Final Drainage Report for Life.Church at Bent Grass Meadows

May 2025

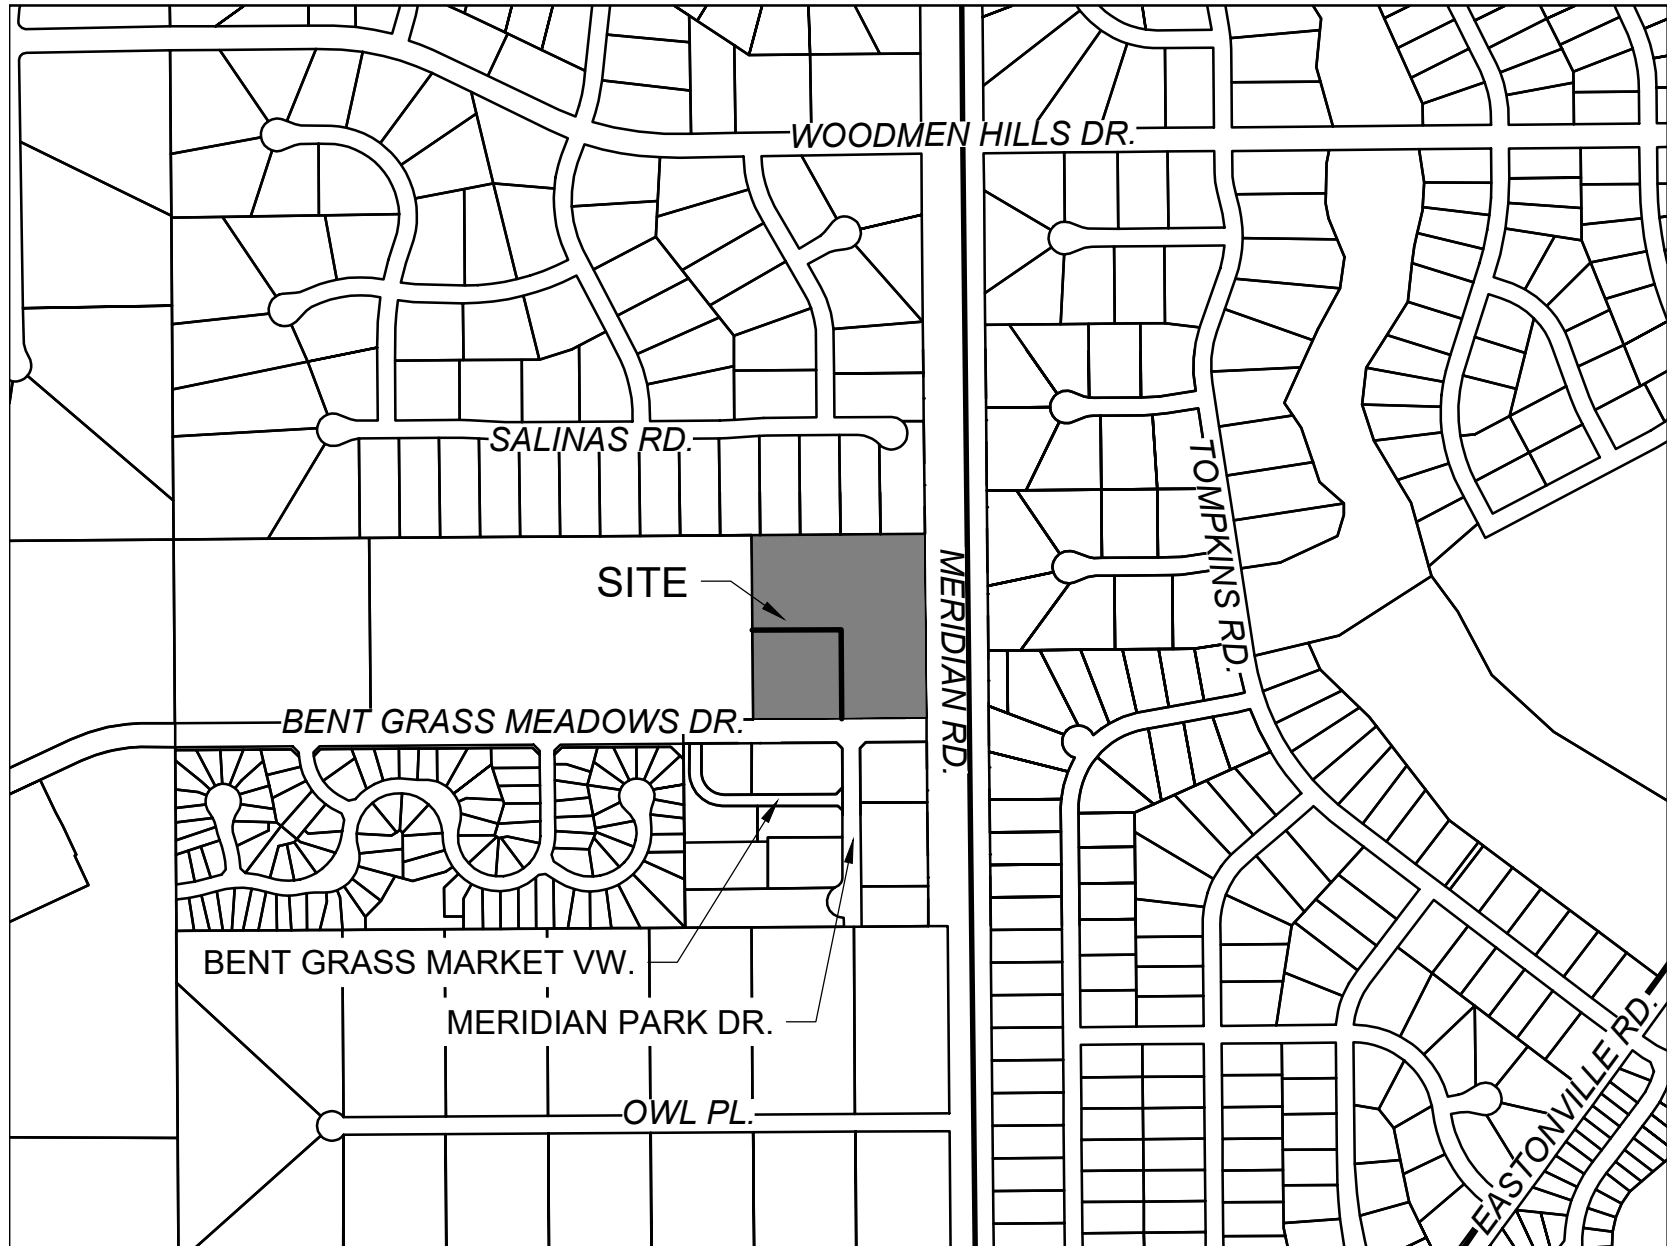
HRG Response:
PCM Cost Estimate added
to report and FAE.
